ADDENDUM NO. 1

Carmel High School Football Scoreboard
2440 Smoky Row Road
Carmel, IN 46032

Carmel High School Football Scoreboards

Project No. 224213.00

T3.02

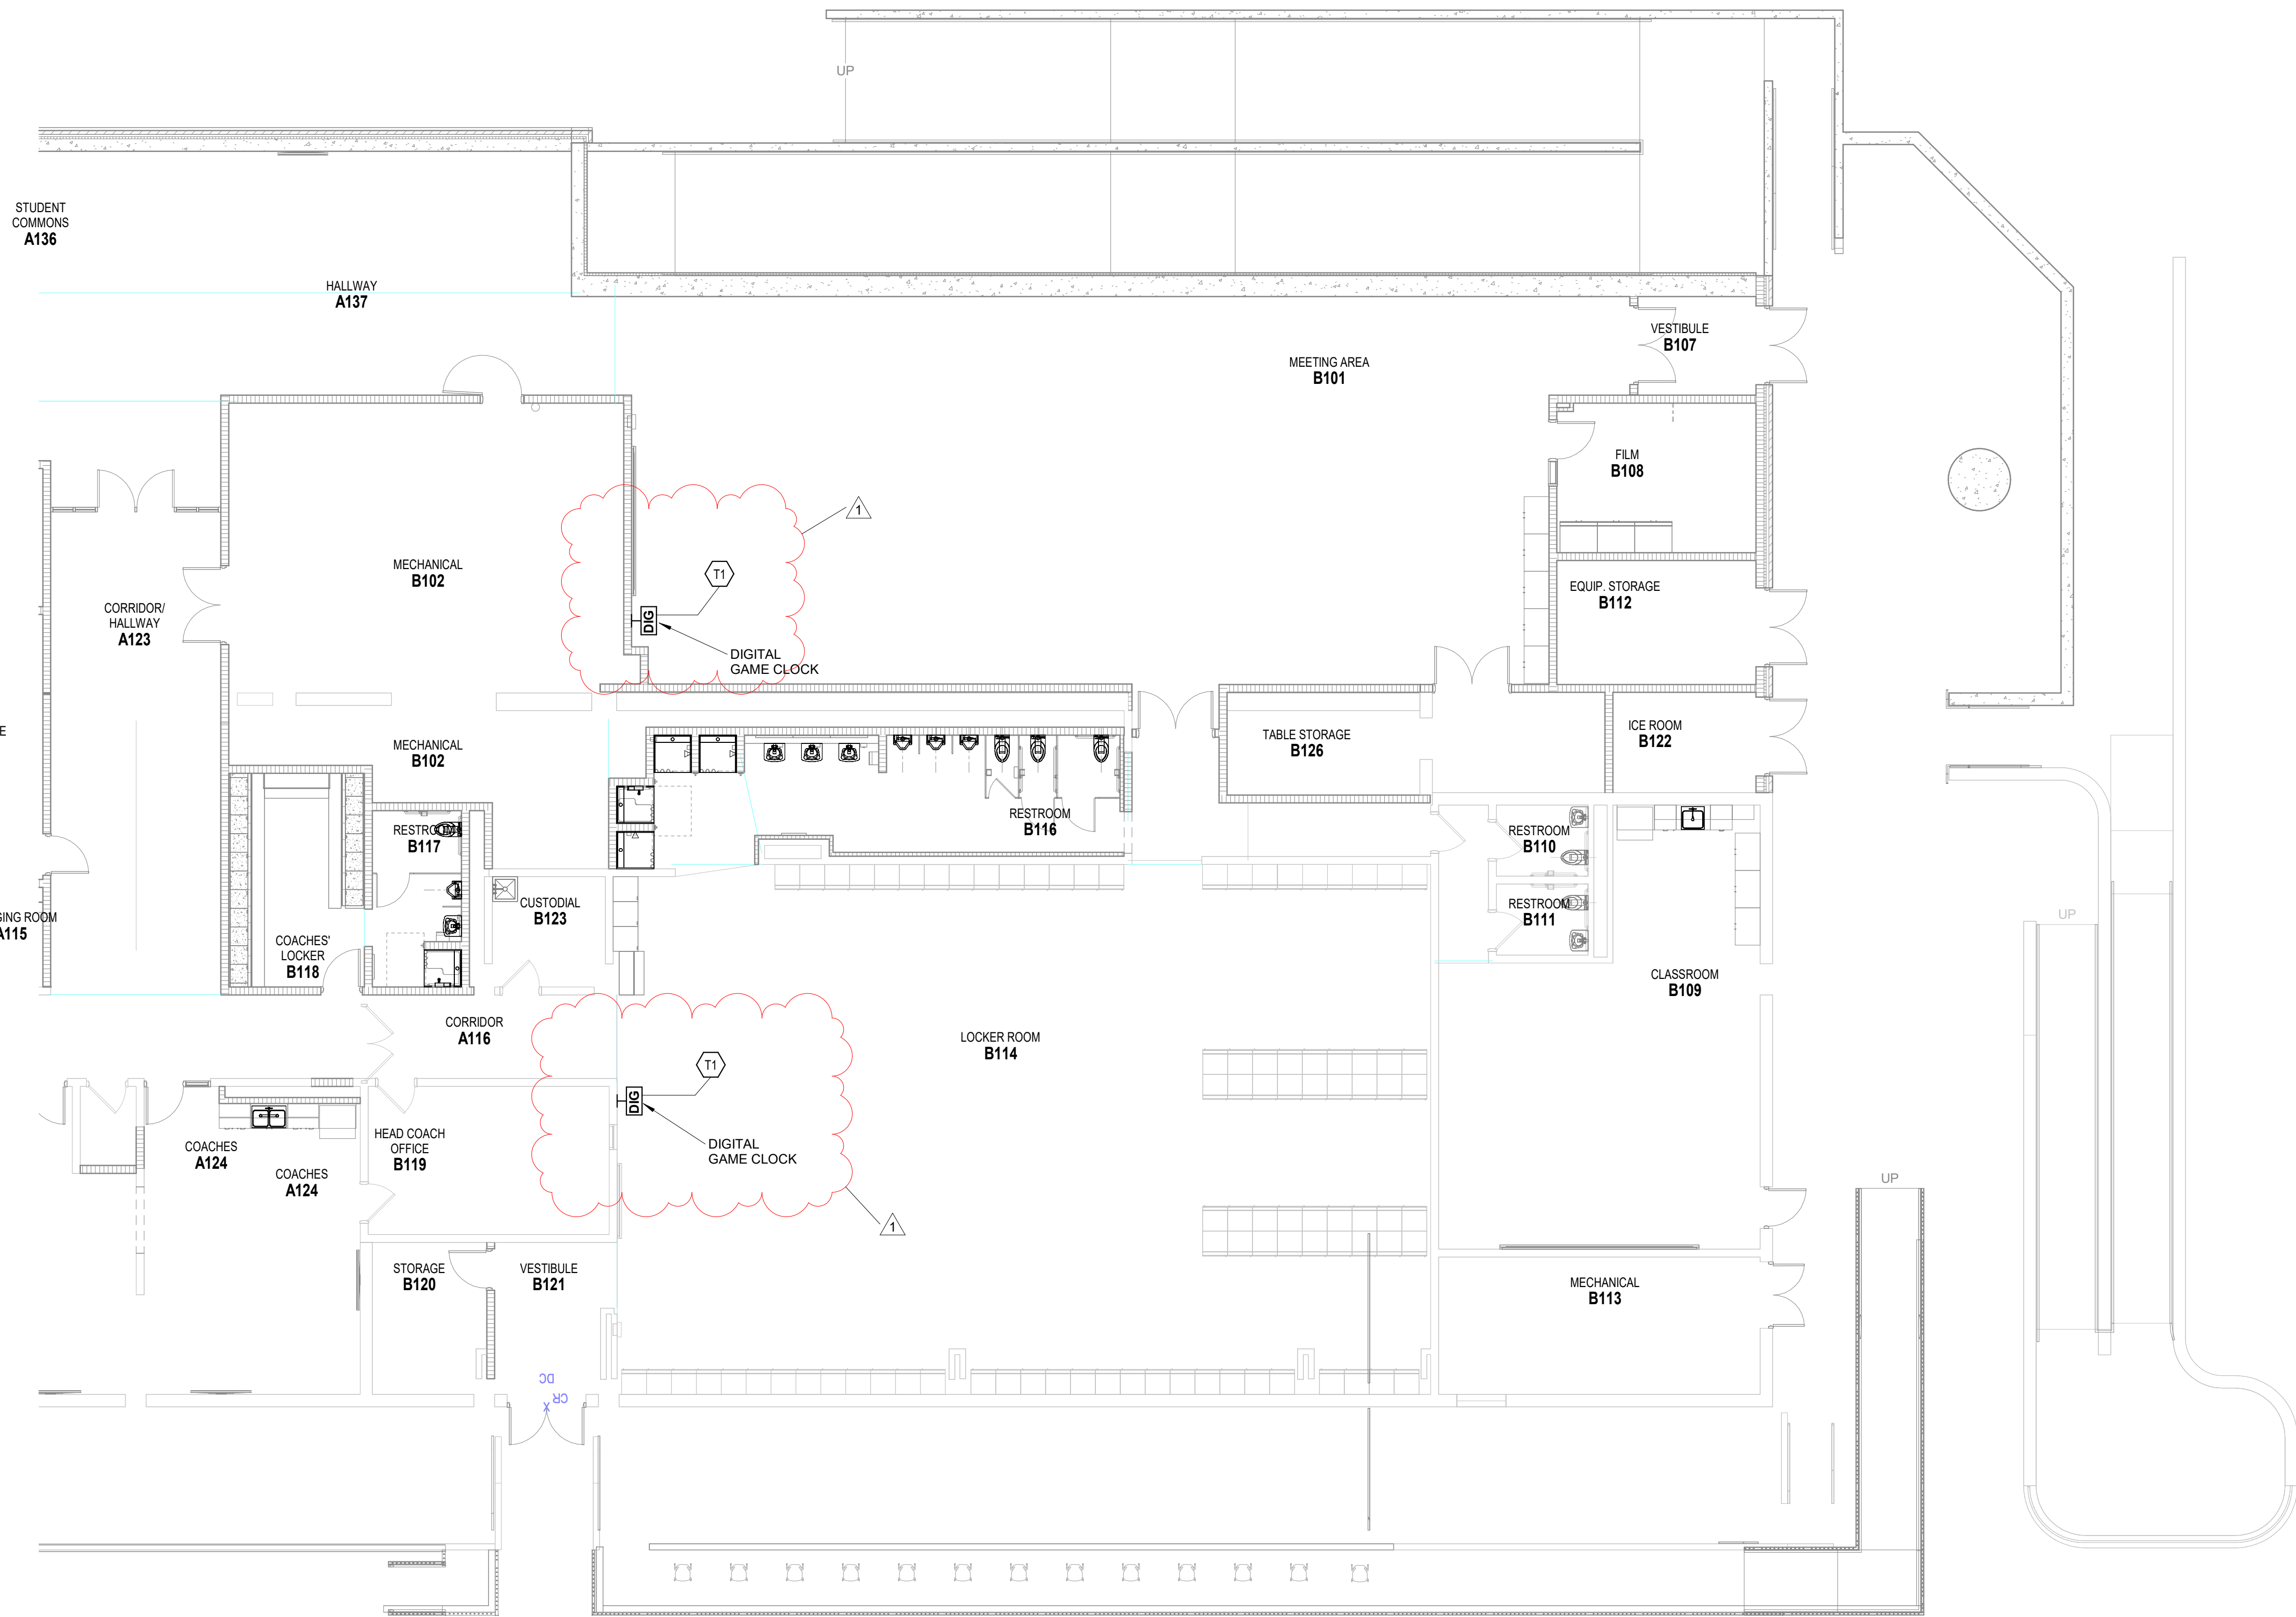
- T1 DAKTRONICS TI-2031 GAME CLOCK. THE 120 VOLT POWER IS TO BE FED FROM THE NEAREST DUPLEX RECEPTACLE CIRCUIT.
